PLANNING DIVISION STAFF REPORT

April 24, 2017

Project Address: 707-713 E. Johnson St. (District 2 – Ald. Zellert)

Application Type: Zoning Map Amendment, Demolition Permit, Conditional Use

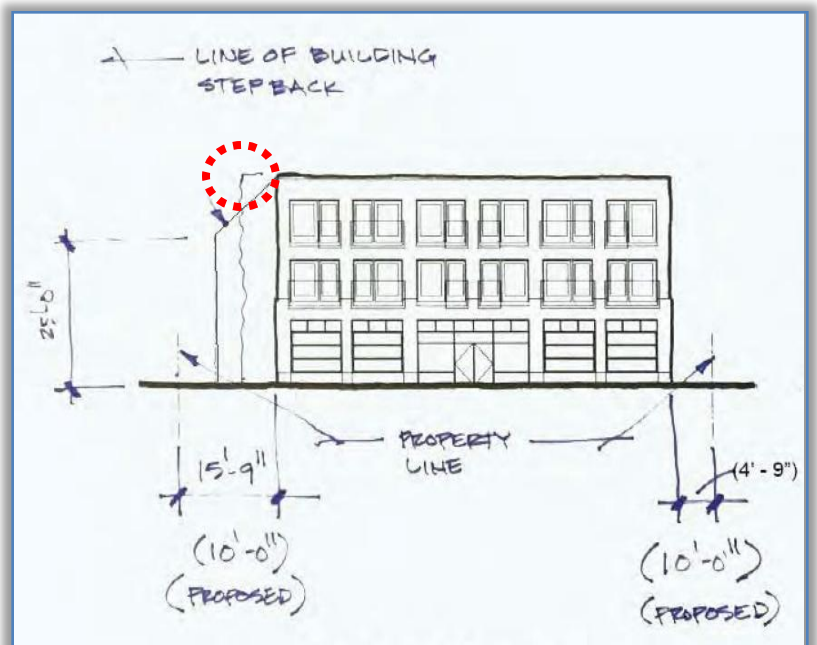
As proposed, the building does not meet the required stepback along the north property line where it is adjacent to an existing 2.5-story, multi-unit residential building (see image below, which was taken from the Applicant's plan set). In order to meet the required stepback, the existing building would need to be setback 15.9', where ten feet is proposed. The modification to the stepback results in a very small portion of the building being in violation of the stepback (circled at right).

The intent of the stepback is to provide a transition between differing levels of intensity as well as to minimize the appearance and 'feel' of a larger building looming over a smaller building. Given the increased side yard setback (ten feet where six feet is required), the separation between the proposed building and adjacent (more than 15 feet), and the two buildings being similar in height, Planning Division staff believes that while the stepback itself is not being

accommodated in the building design, the intent of the stepback is being met. In addition, the Applicant has proposed a three-foot decorative screen fence along the northern shared property line. As recommended in the Zoning Conditions, the height of the fence will be increased to six feet, which will also provide additional screening and mitigation to noise and light.
